PROPOSED NEW RESIDENCE  
LOT 65 MYERS RD.  
DENMARK  
FOR G YAP

**Re: Lot 65 Plan 23286, Myers Road Denmark**

Thank you for meeting with us on Monday 25 July to discuss the unapproved buildings constructed on Lot 65 Plan 23286, Myers Road Denmark. This letter is to follow up that discussion and formally document our concerns.

# SITE VISIT RECORD FORM

## SHEET NAME: ENVELOPE PLAN

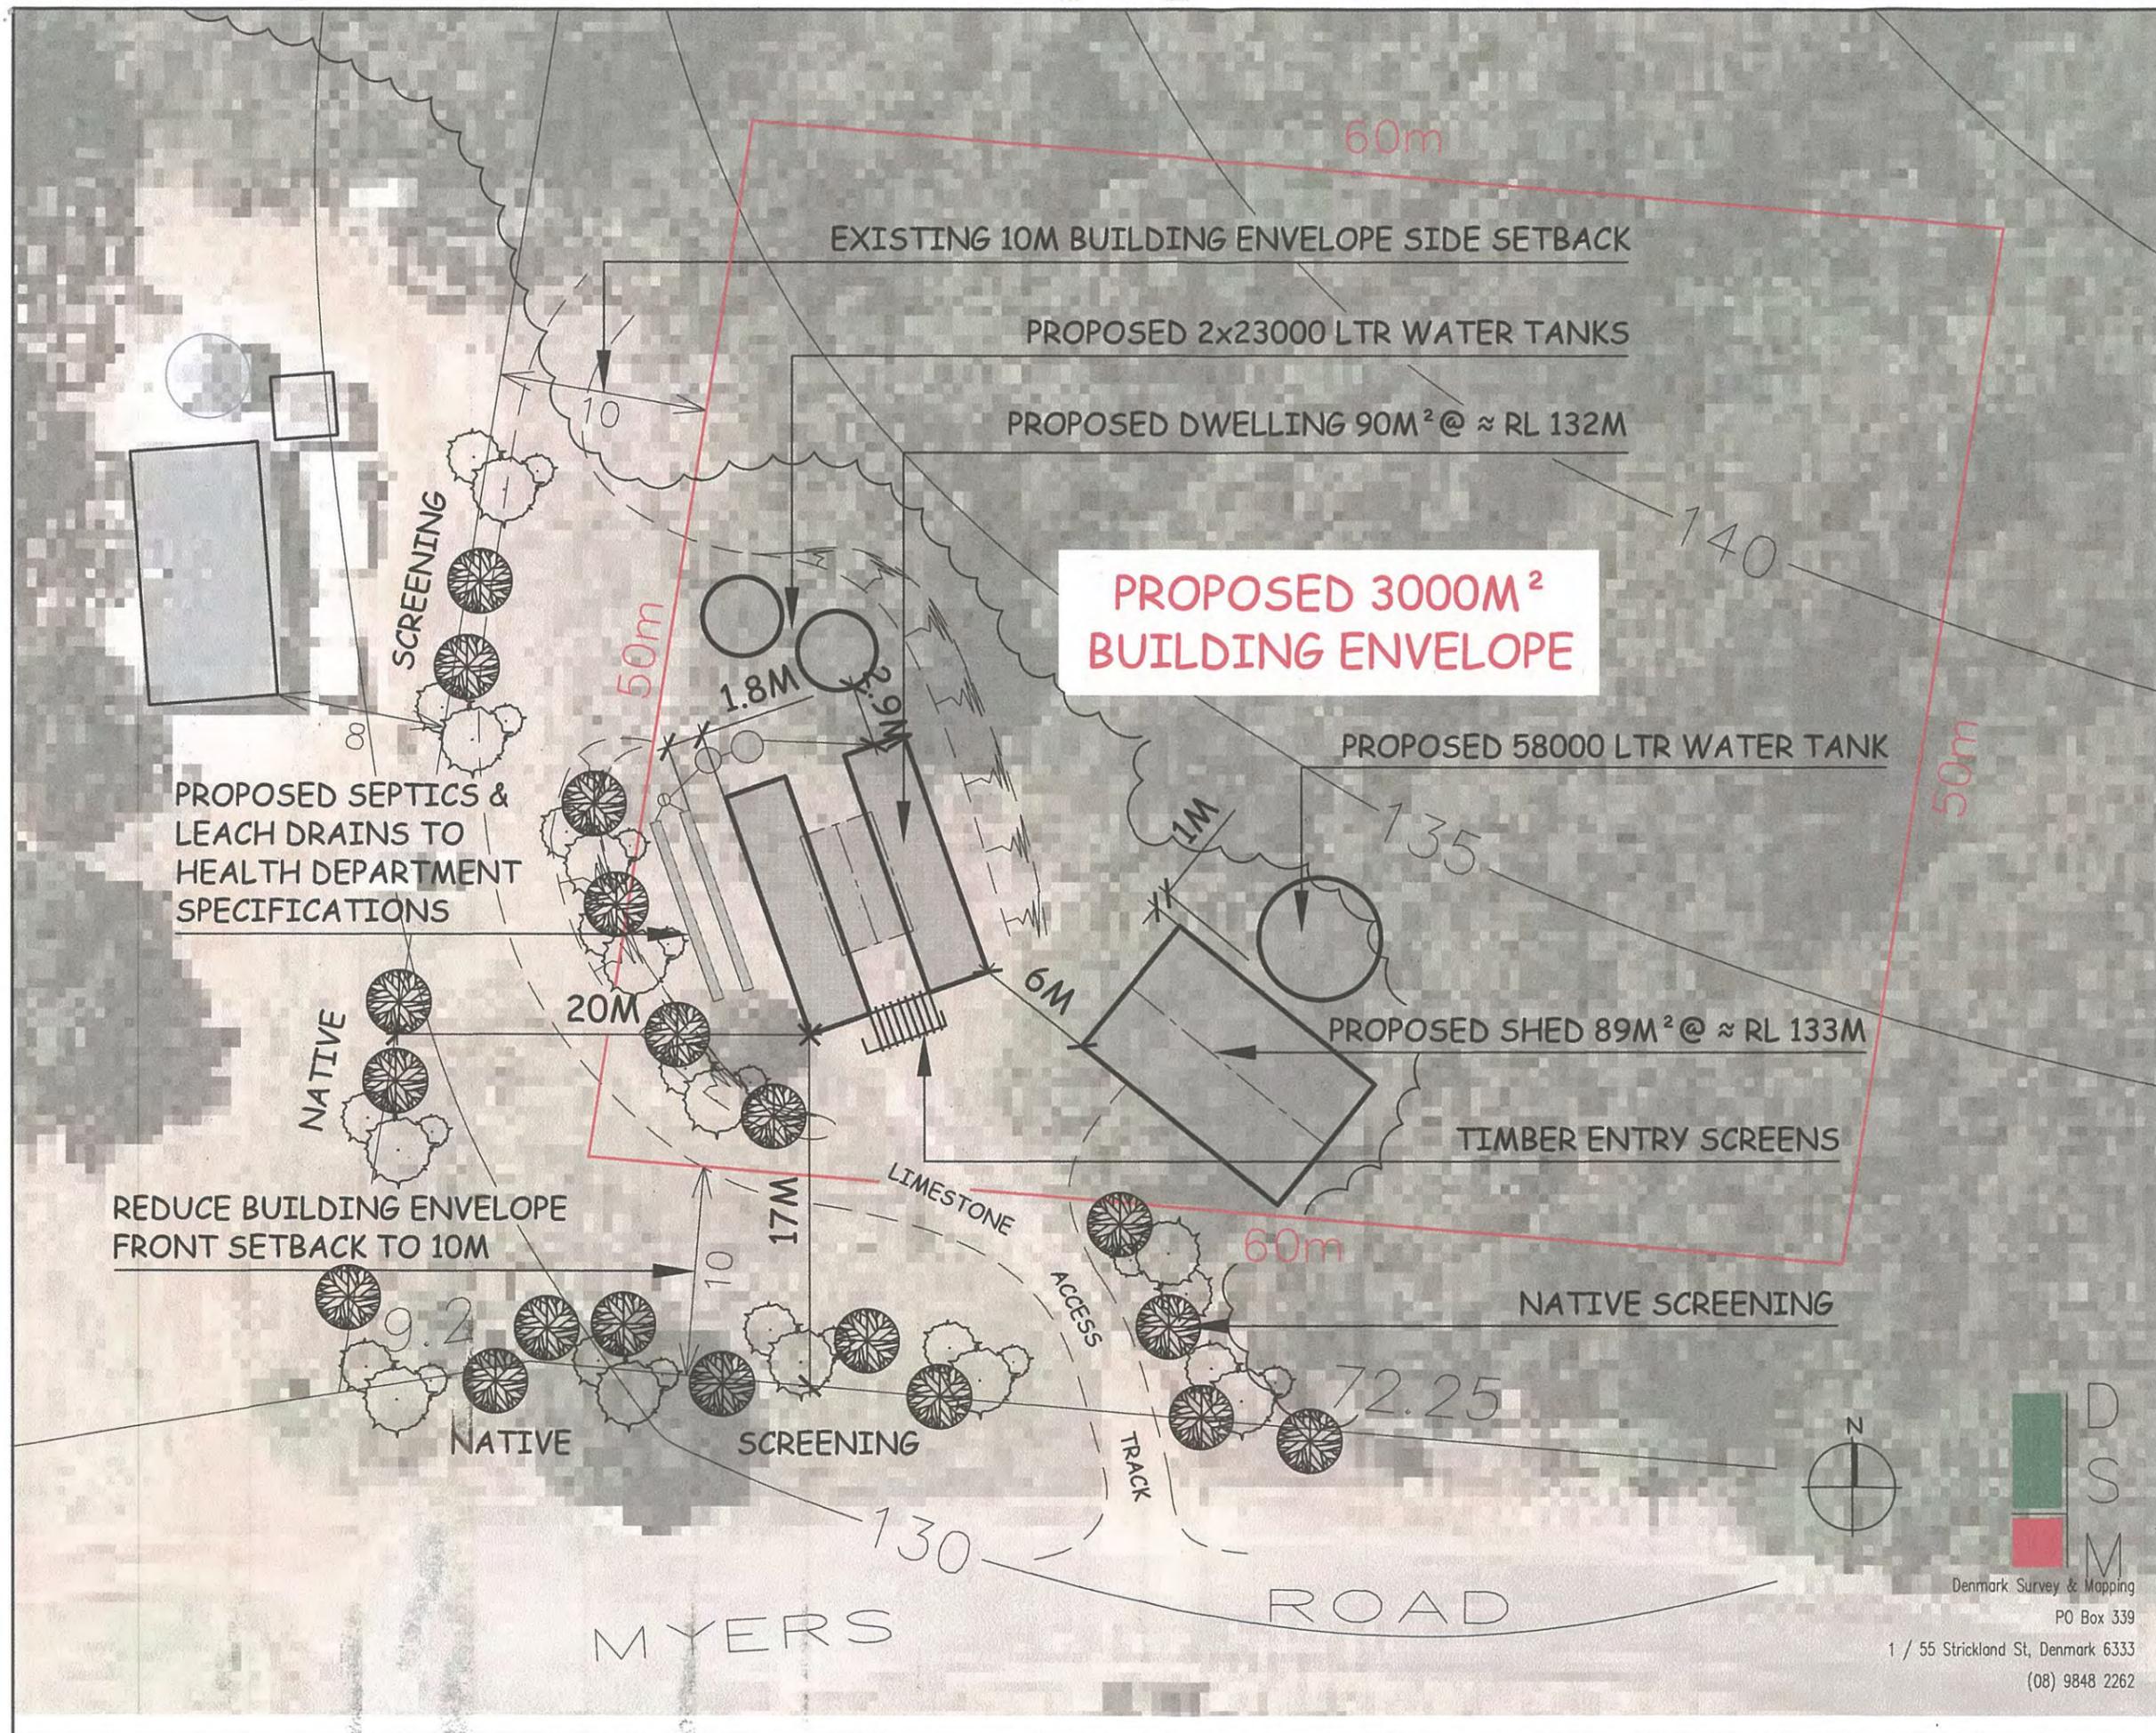
REVISION No.	REVISION
1	REVISE ENTRY
2	SCREENING TO BATTER

SHEET NAME:  
**FLOOR PLAN ELEVATIONS**

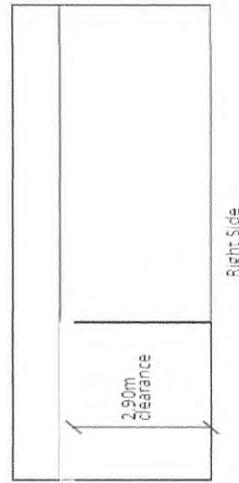
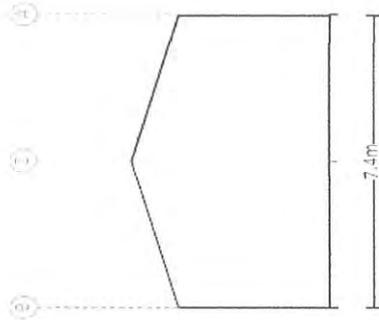
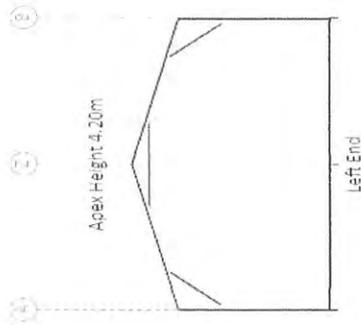
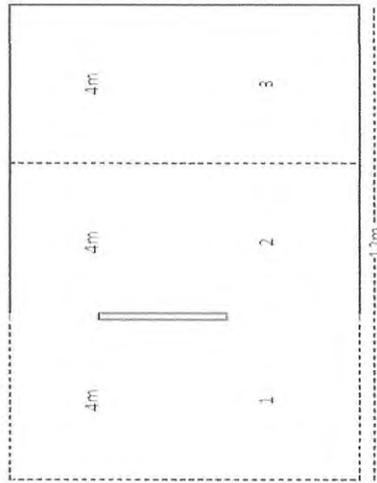
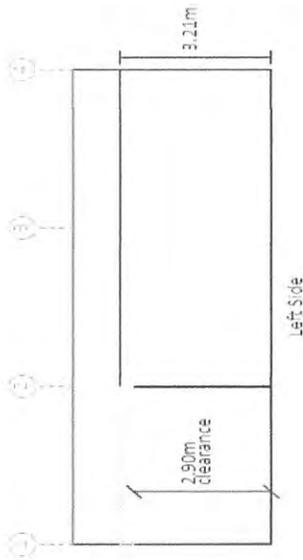
REVISION	CHANGE PITCH ALFRESCO	REVISE CLADDING	ADD WINDOWS & AWNINGS
No. 1			
No. 2			
No. 3

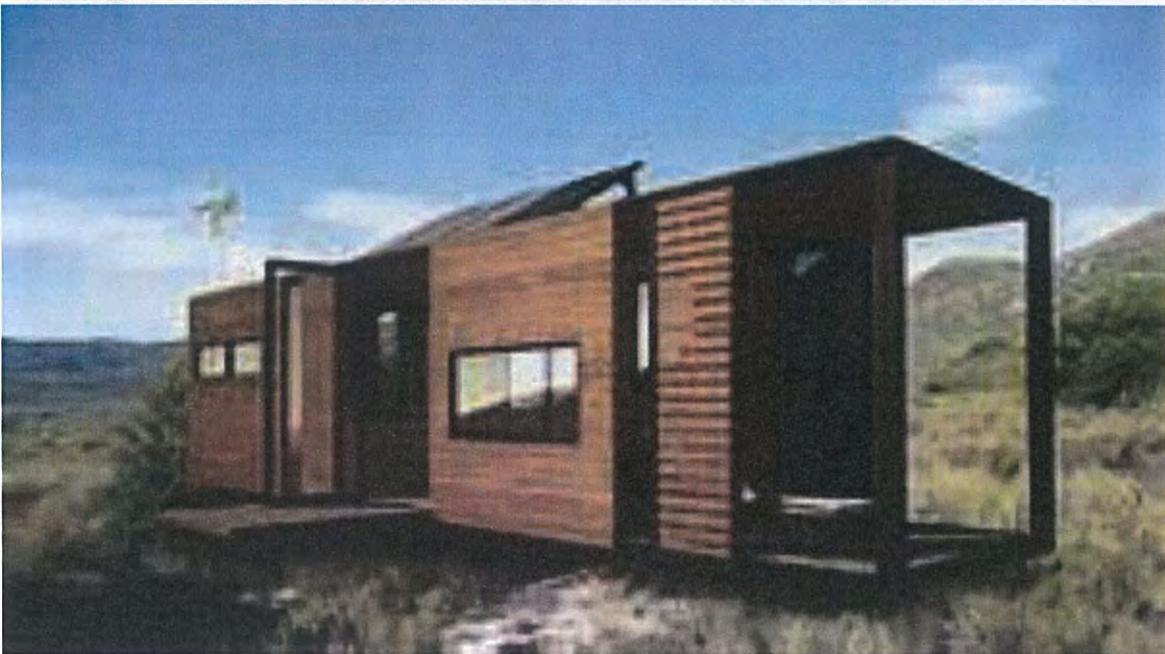
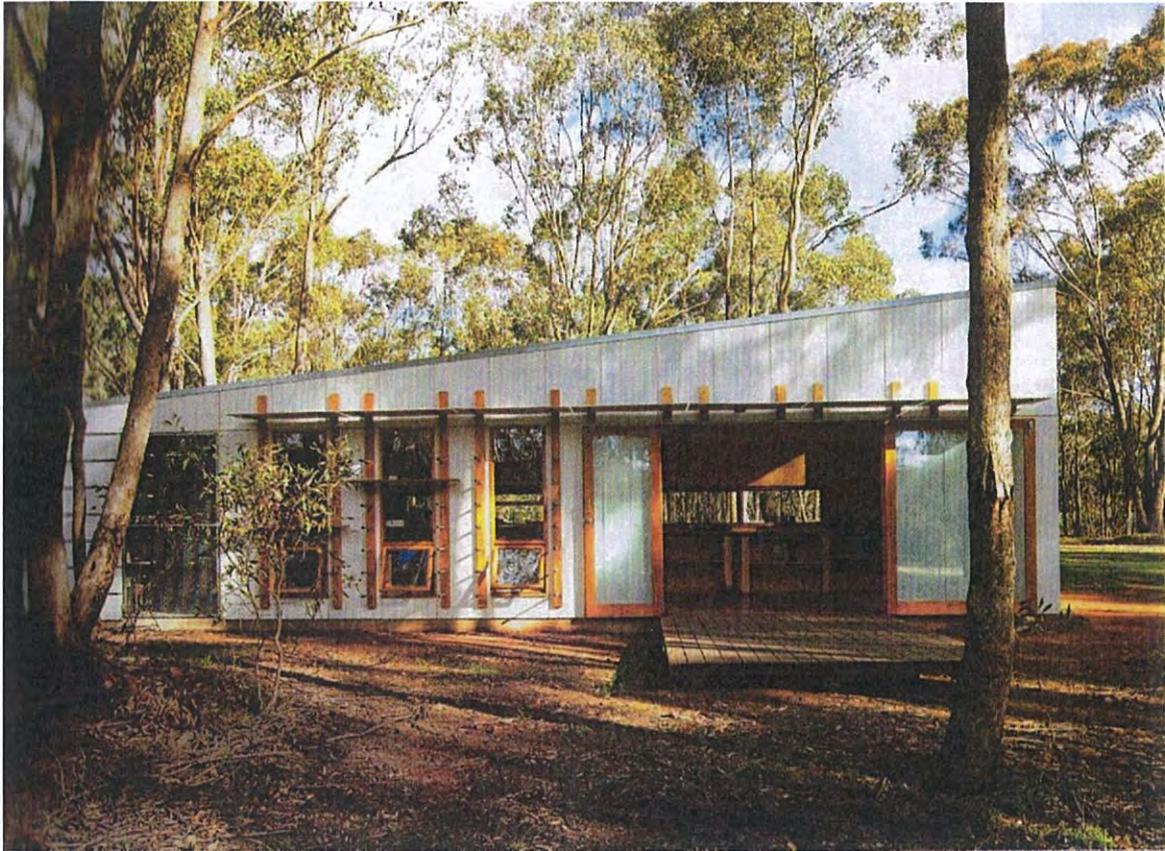
- 2) A Bushfire Attack Level (BAL) Assessment by an accredited bushfire consultant is in progress.
- 3) Elevations, height dimensions as well as details regarding roofed alfresco are as addressed in attached plans.
- 4) Use of quality screening panels will address amenity issues for transportables as illustrated: they will shield the alfresco area so that the area will not be visible from the road as well as to cover potential clutter such as bicycles and footwear. Utilities such as wheelie bins will be placed out of sight from all neighbours and tastefully concealed.
